## VVVF4 to VVVF5 Adaption Instructions

The following adaption will need to be made in order to use the upgraded VVVF5 door control module in place of a VVVF4 or VVVF4+ unit.

VF motor plug position in VVVF5 unit

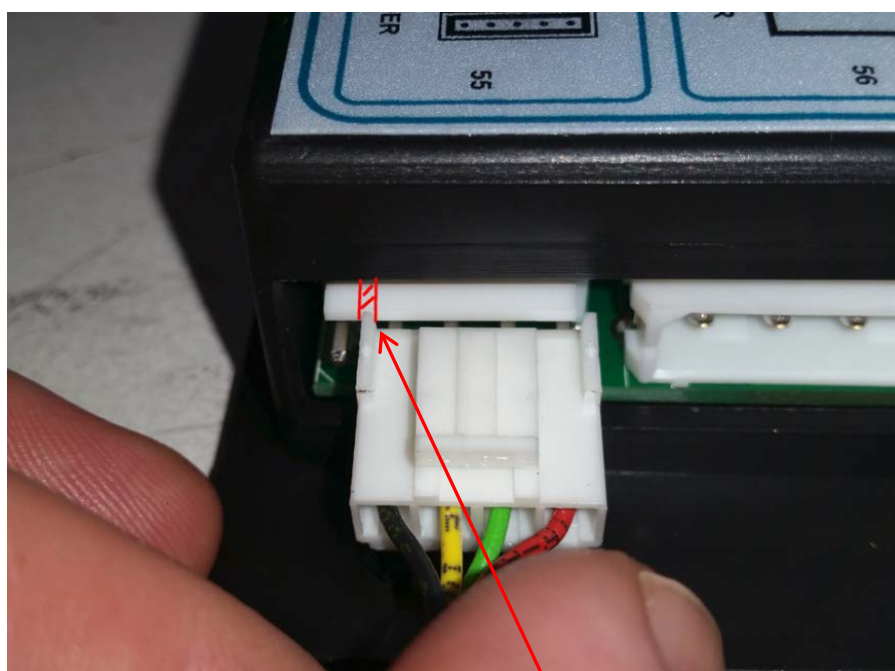
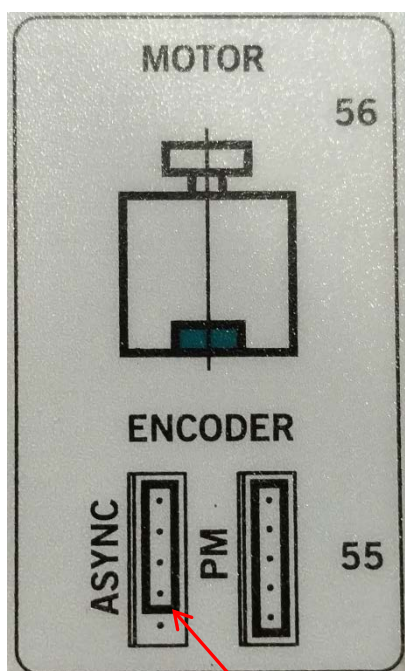
The existing VF motor plug should be positioned in the input side of the new VVVF5 unit using the top 4 pins. A small section should be cut away using cutters from the input plug of the VVVF5 unit in order for the existing motor plug to fit correctly as shown below:

Cut away highlighted section
